Access Compliance Report Public Rights-of-Way (Curb Ramps)

Main Street: BENT_TWIG_LN Cross Street: BROWNING_AVE Location: N

ADA ID: RPAT211021150902 Ramp Type: Type 1 - Perpendicular Diagonal Initial Pass/Fail: Pass Overall Compliance: No Severity Score: 14

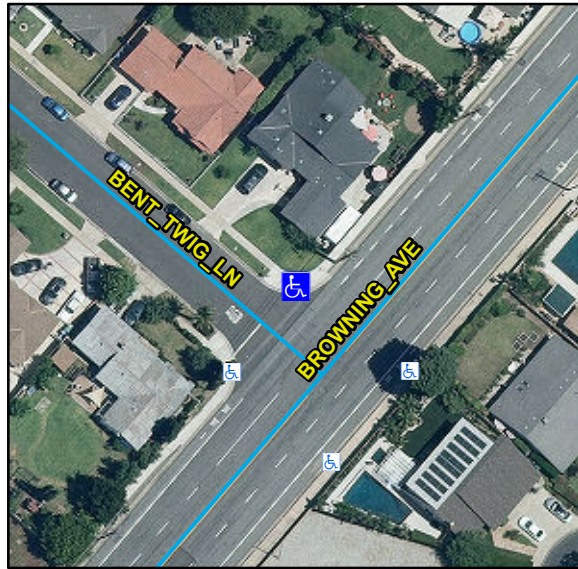
Remove & Replace Curb Ramp With Two New Directional Ramps or Equivalent. Remove & Replace Gutter.

R304.2.1, R304.5.3, R304.2.3, R304.5.4, STD 1115
